Carrickmines-Shanganagh River Flood Relief Scheme

An Coimisiún Pleanála Submission Response Note

Case # ABP-321937-25

Figure 1.1: Locations of Traffic Count Survey

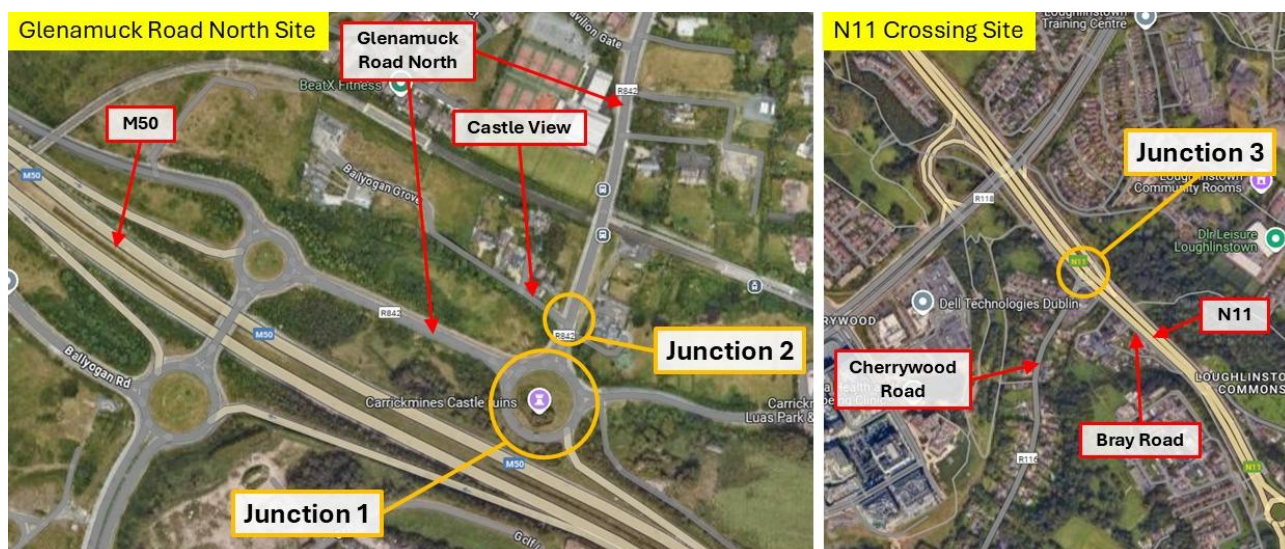
At the meeting on 13th August, TII requested further details in relation to the methodology of open cut construction at the N11 dual carriageway beyond that described in the presentation and EIAR. A detailed constructability assessment with traffic management plans within fixed hours is provided in Appendix 3. A copy of this constructability assessment statement has been provided to TII as a follow up to recent consultations.

A classified traffic count was undertaken on Tuesday, 27th May 2025. The count was carried out over the 24-hour period and included both the morning and evening peak periods. The data was chosen while schools were open to ensure the maximum volume of traffic was included. The count was designed to identify the critical peak hour periods of traffic flow in the vicinity of the subject sites. Data was collected in 15-minute intervals and the following count classifications were employed:
